This manuscript presents an unprecedented evaluation of 23 (sub)daily (quasi)global precipitation (P)datasets across 16,295 catchments worldwide using hydrological modeling. The 23 P datasets belong to six major families of data sources: satellite only, reanalysis only, rain gauge only, satellite and rain gauge, satellite and reanalysis; and satellite, reanalysis and rain gauge. The conceptual hydrological model HBV was used to simulate the conversion of precipitation into streamflow at the daily temporal scale. Each P dataset, along with air temperature (from MSWX) and potential evapotranspiration (computed using the Hargreaves formula), are used to drive the hydrological simulations. The modified Kling-Gupta efficiency (KGE') is used to evaluate the performance of the simulated streamflows against daily observations, and serves as a proxy for the performance of the P datasets.

This manuscript addresses an important topic for the hydrometeorological community. The manuscript is well written, concise and clear, with updated references. Unfortunately, the manuscript lacks a clear scientific question or hypothesis to be tested, and the Methodology section does not provide enough sci

Fig. Variation in HBV performance (median KGE) with permafrost fraction and glacier fraction for all 23 P datasets.

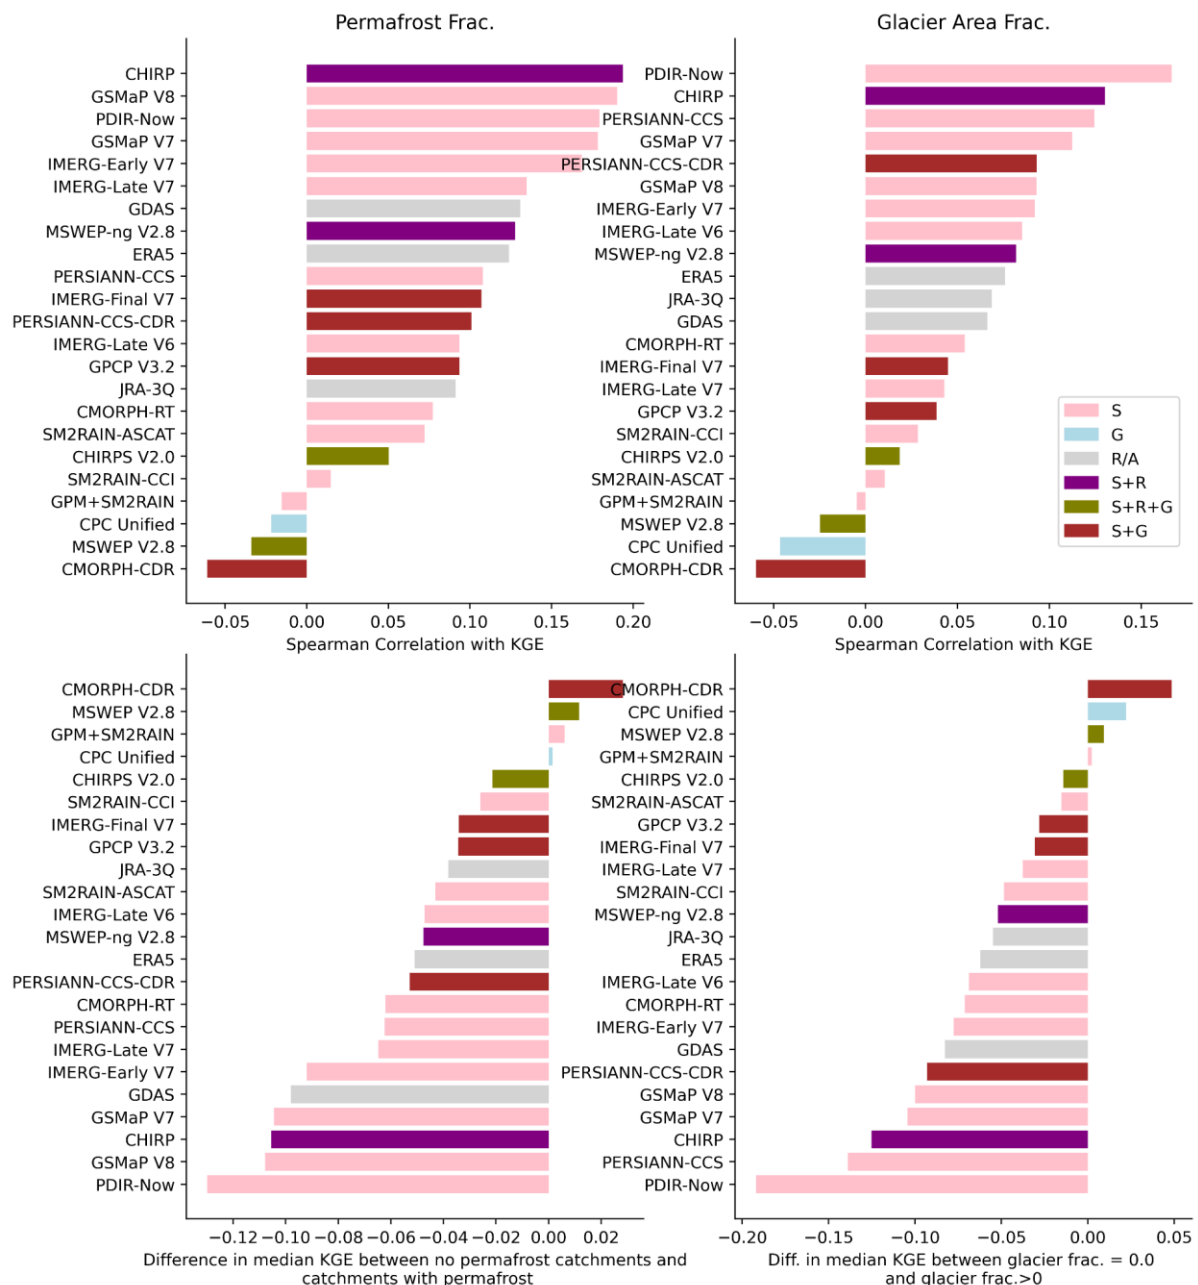
47. Table B1. Considering the existence of the attribute "*Permafrost fraction*", why the attribute "*Glacier fraction*" was not included in the analysis?

Response: The reason for not including "glacier fraction" in Table B1 is that its behavior closely mirrors that of "permafrost fraction." To support this point, we calculated the glacier fraction using the Randolph Glacier Inventory dataset Version 7.0 (RGI 7.0, 2023). The relationship between HBV performance (median KGE) and both permafrost and glacier fractions is shown in the following figure. These charts indicate that for datasets such as CMORPH-CDR, MSWEP V2.8, CPC-Unified, and GPM+SM2RAIN, both glacier and permafrost fractions exhibit a negative correlation with KGE. In contrast, the remaining datasets show a positive correlation with both variables. This similarity in behavior suggests that permafrost and glaciers exert comparable influences on model performance, and therefore, we opted to include only the permafrost fraction in our analysis.
